UNITED STATES PATENT AND TRADEMARK OFFICE

APPLICATION NO.	FILING DATE	FIRST NAMED INVENTOR	ATTORNEY DOCKET NO.	CONFIRMATION NO.
10/692,084	10/23/2003	Harald Richter	JAE32USA	8309

Office Action Summary

DETAILED ACTION

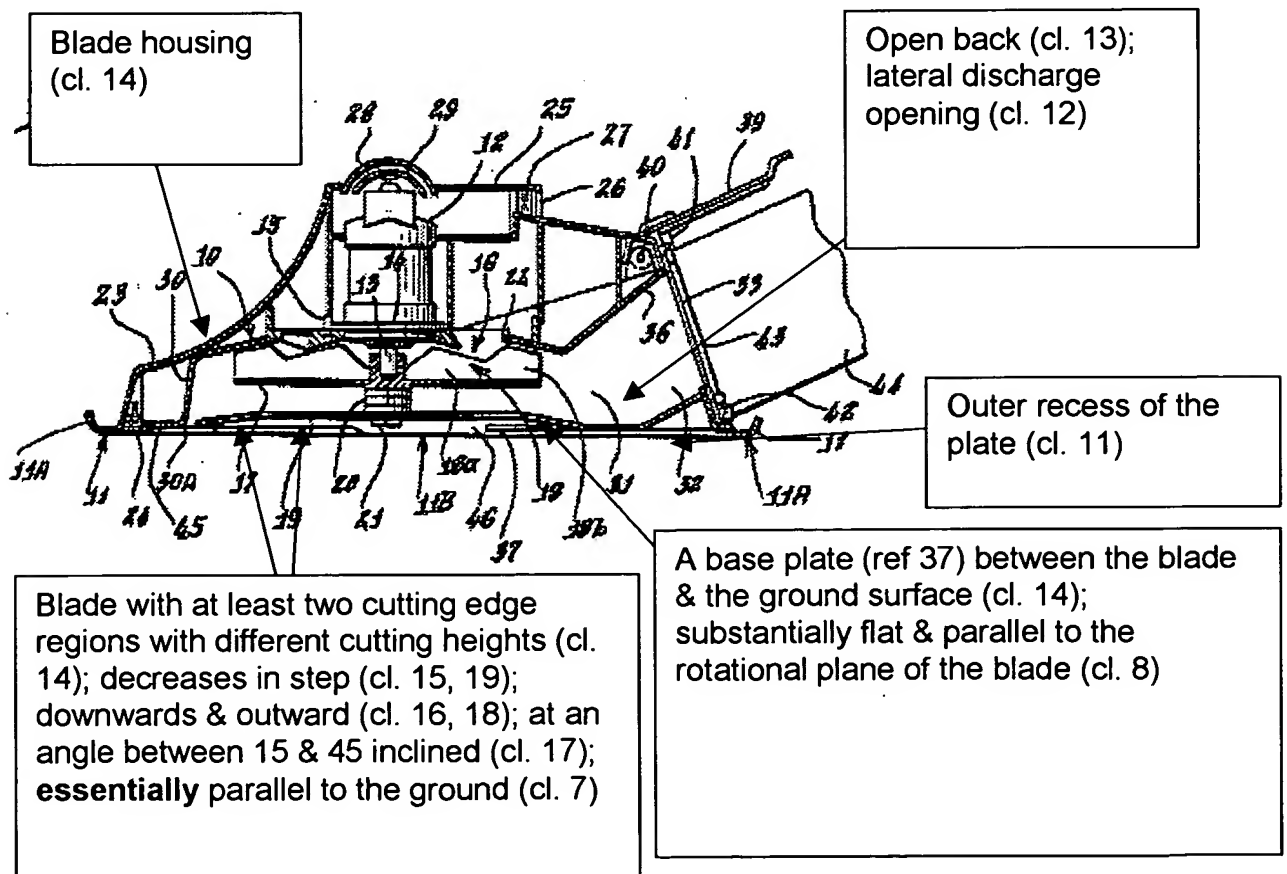
Martin discloses:

Martin discloses the claimed invention except for showing the base plate being arranged on the front region of the mower.

It would have been obvious to one having ordinary skill in the art at the time the invention was made to arrange the base plate at any location of the blade housing, since it has been held that rearranging parts of an invention involves only routine skill in the art. *In re Japikse*, 86 USPQ 70.

Martin discloses the claimed invention except for size of the base plate being as large as to extend from the front to **approximately** a middle of the blade housing.

It would have been an obvious matter of design choice to make the base plate any size, since such a modification would have involved a mere change in the size of a component. A change in size is generally recognized as being within the level of ordinary skill in the art. *In re Rose*, 105 USPQ 237 (CCPA 1955).
